6574A-09

S E R V I C E N O T E

**6574A - DC POWER SUPPLY, 0-60 V, 0-35 A, 2100 W
MANUALLY CONTROLLED**

The four filter capacitors circuit reference (C416-C419) on the A4 AC input board starts leaking electrolyte

Situation:

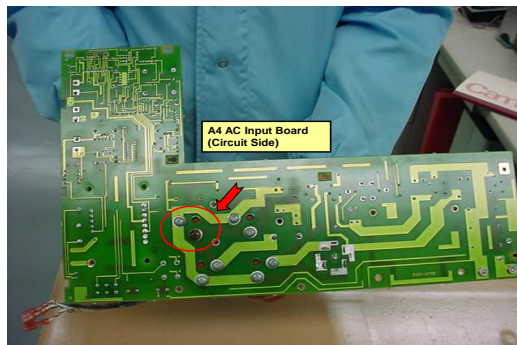
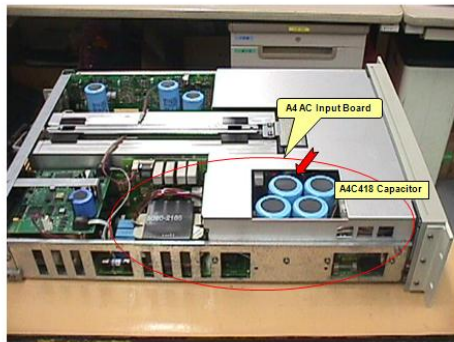
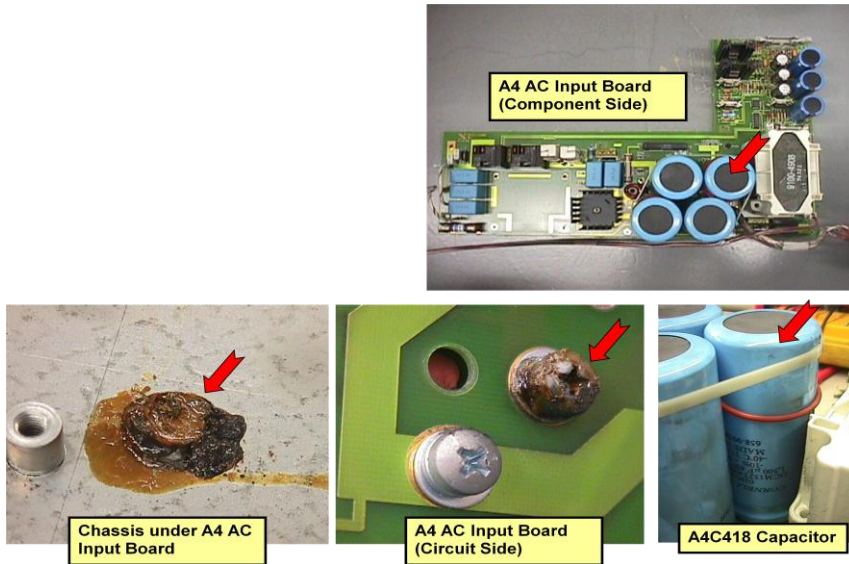
The four filter capacitors circuit reference (C416-C419) on the A4 AC input board starts leaking electrolyte - not through the pressure valve in the bottom as one would expect but through one of the terminal screw bushings.”

The screw P/N 2680-0217 length currently being used was not considered and the length was overlooked. The screw length is 0.375 inches long. We have found that the screw can be 0.055 inches too long and may bottom out causing the tapped hole in the header of the capacitor to become cracked or become broken.

When this happens the electrolyte will slowly leak out over time, and cause the defect described. This situation is even worse due to the capacitor is mounted with the header face down. If the capacitor was mounted header face up a cracked or broken header would not have caused this problem, the electrolyte could not leak out.

1. All affected models and tested assemblies WIP (Work In Process), FGI (Finished Goods Inventory) at SPO (Support Parts Organization) & AMC (Asian Manufacturing Center) has been inspected for capacitors with damaged headers due to the incorrect screw
2. When this repair is being done all of the hardware described above should be replaced (It is NOT recommended that any of the hardware be reused)
3. The following figures can be used when doing the repair.
4. Inspect the assembly as described below.
5. The last figure will aid in the reassembly of the hardware and the capacitors.
